# CHANGE ORDER

**Elections Balloting Facility**  
3000 Rockefeller  
Admin West 3<sup>rd</sup> Floor  
Everett, WA. 98201

Date: **03/05/2024**  
CO No: **PW23-013SB-CO-05**  
Contract No: **PW23-013SB**

## RFI #53: Coiling Door Support Details

[Backing layout.pdf](#)

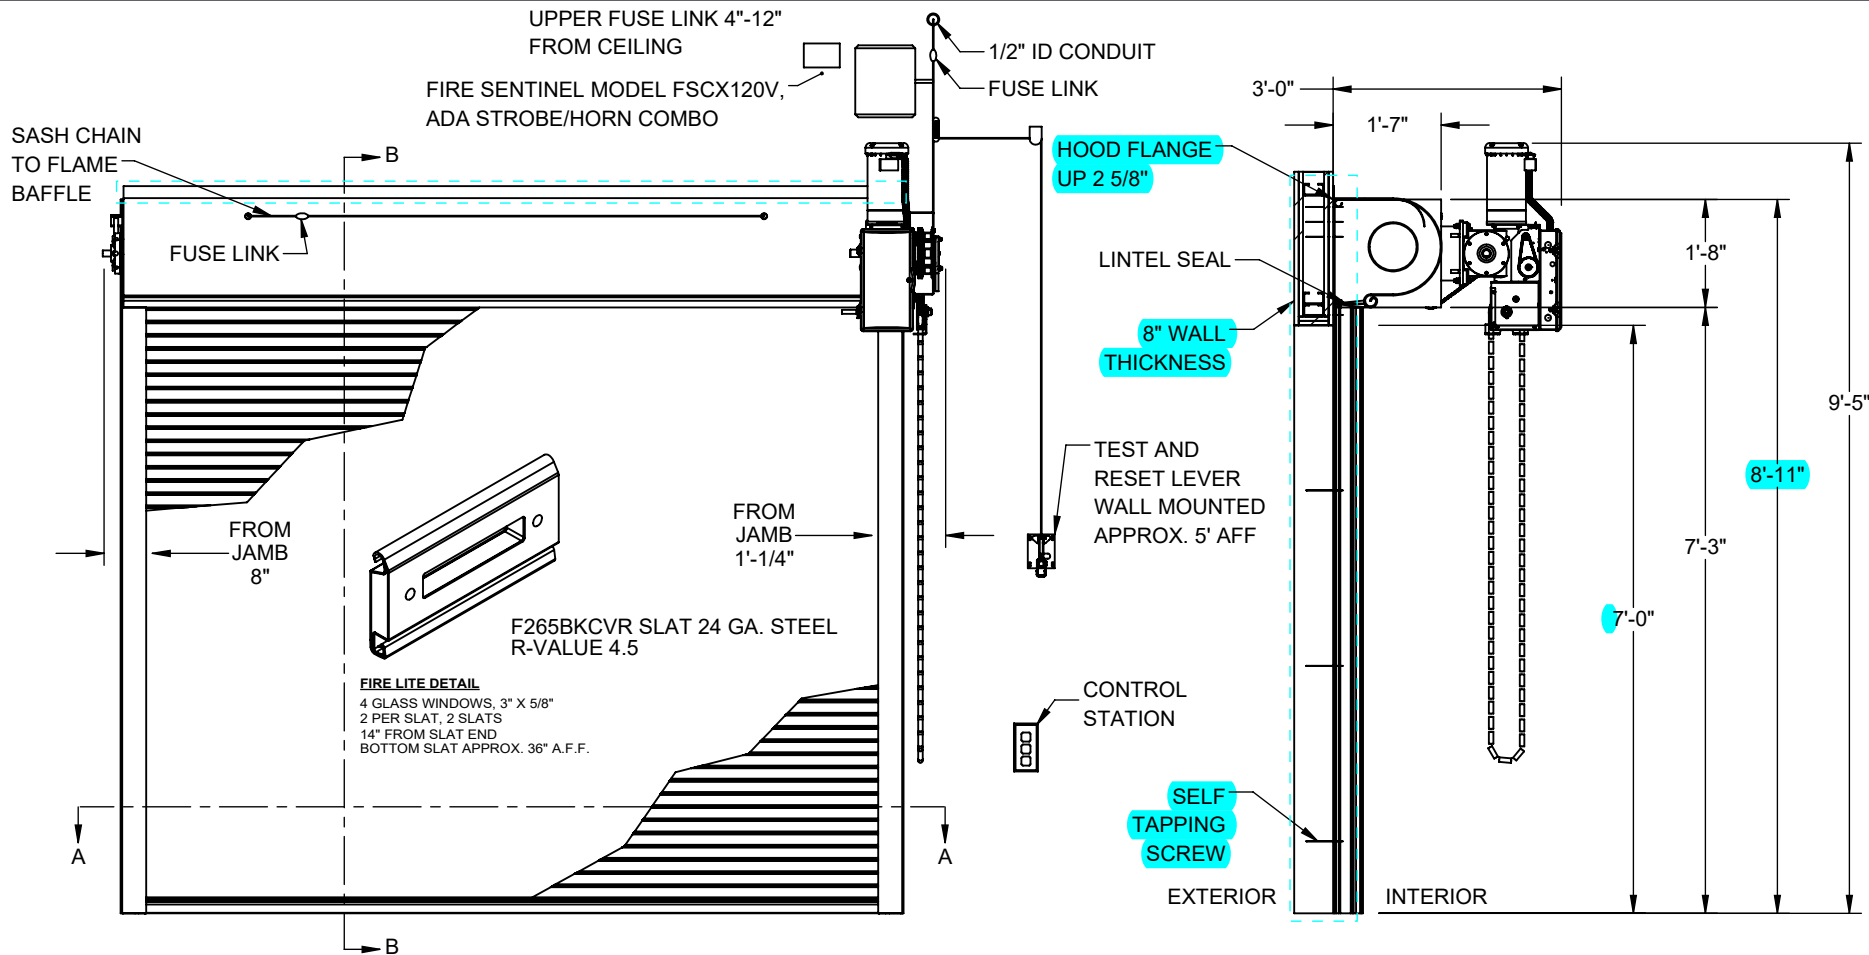
There are no details that show support/backing for the overhead coiling doors. currently, all framing is assumed to be 20 GA studs. Per the approved coiling doors shop drawings, they require min 14 GA studs as supports for the coiling doors. We have also confirmed with installer that the walls don't need to be thickened to 8" as shown in the shop drawings.

Please confirm we are to use 14 GA studs for framing at the coiling doors as shown in the shop drawings.

Please use the manufacturer's recommended installation and support/backing at coiling doors.
